Well Name: JRU APACHE FEDERAL COM	Well Location: T22S / R30E / SEC 24 / NESE / 32.376378 / -103.82825	County or Parish/State: EDDY / NM
Well Number: 906H	Type of Well: OIL WELL	Allottee or Tribe Name:
Lease Number: NMNM89051	Unit or CA Name:	Unit or CA Number:
US Well Number:	Operator: XTO PERMIAN OPERATING LLC

Sundry ID: 2827610

Type of Submission: Notice of Intent	Type of Action: APD Change
Date Sundry Submitted: 12/16/2024	Time Sundry Submitted: 09:49
Date proposed operation will begin: 12/30/2024

PECOS DISTRICT DRILLING CONDITIONS OF APPROVAL

Figure B – 3 String Design – Open Production Casing Annulus (Updated May 2024):

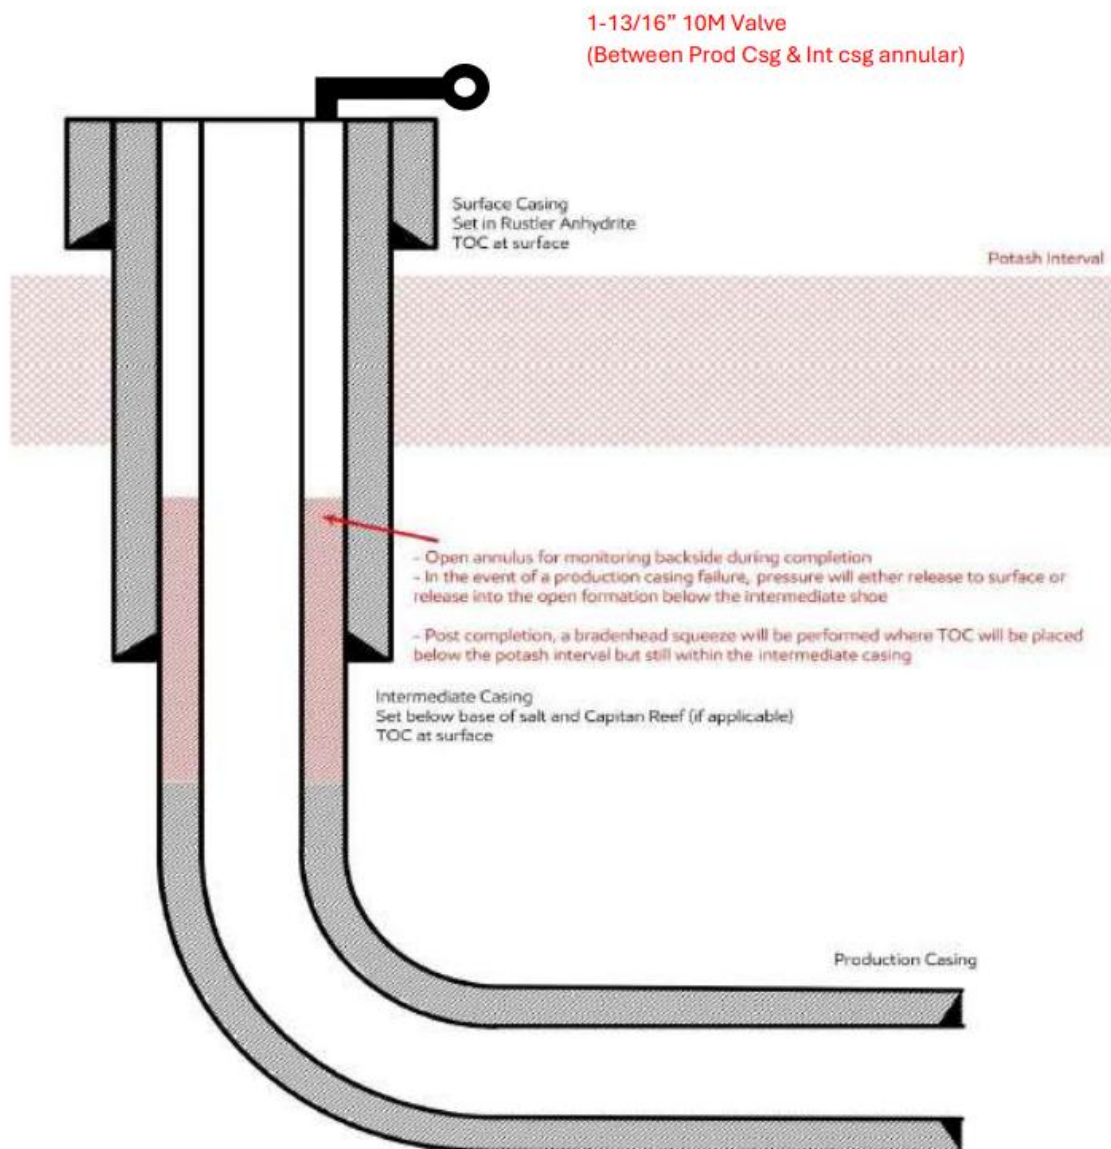
XTO is aware of the R-111-Q update & will comply with these requirements including (but not limited to):

1. Alignment with KPLA requirements per schematic above, leaving open annulus for pressure monitoring during frac and utilizing new casing that meets API standards
2. Contingency plans in place to divert formation fluids away from salt interval in event of production casing failure
3. TOC in the annulus between intermediate & production casing string shall stand uncemented at least 500 feet below the intermediate casing shoe
4. Bradenhead squeeze to be completed within 180 days after hydraulic frac operations have been concluded to ensure at least a 500 feet tie-back has been established inside salt string but with top below MB 126
